## **Addendum Two**

### **The Renovations & Restorations of the Westport Community Center**

Issued: Friday, December 8, 2016

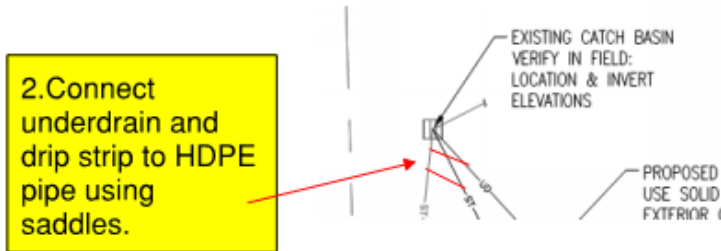
10. How much of the temporary heat is the town going to cover? %, time or \$ amount will help narrow the bid down.

The Town of Westport will provide temporary heat to the main and upper floors of the building. All heat in the basement to accommodate concrete work shall be the responsibility of the General Construction Contractor.
